HORSHAM DISTRICT COUNCIL CONSULTATION

TO:	Horsham District Council – Planning Dept
LOCATION:	Land To The Rear of The Copse Worthing Road Horsham West Sussex
DESCRIPTION:	Construction of up to 23 residential dwellings, (including 9 affordable homes), including access, parking, landscaping and other associated infrastructure works.
REFERENCE:	DC/26/0355
RE-CONSULT:	1 st set of comments in black 2 nd set of comments in blue 3 rd set of comments in green
RECOMMENDATION:	Holding Objection / More Information / Modification Advice / Modification No Objection

SUMMARY OF COMMENTS & RECOMMENDATION:

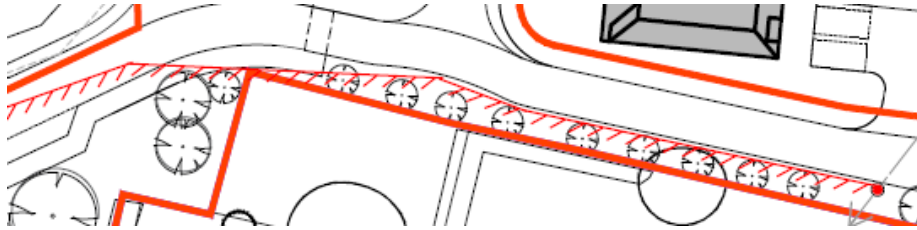
3. Multiple discrepancies are noted between the Illustrative Landscape Masterplan (ILS), Landscape Design Strategy, Site Layout Plans, Planning Statement, BNG Proposed Plan and Drainage Strategy within the Flood Risk Assessment

- iv. 67 trees are indicated within the Phase 2 RLB of the Landscape Design Strategy[Amended, with thanks. Closed.](#)
 - c. Proposed hedgerow differs between documents
[Discrepancy remains within documents. See ILS \[below, left\] and Site Layout \[below, right\], the latter of which features only part of proposed hedgerow. Nonetheless, hedgerow as detailed within the ILS can be secured via condition. Closed.](#)
[Details are now coordinated, with thanks. Closed.](#)
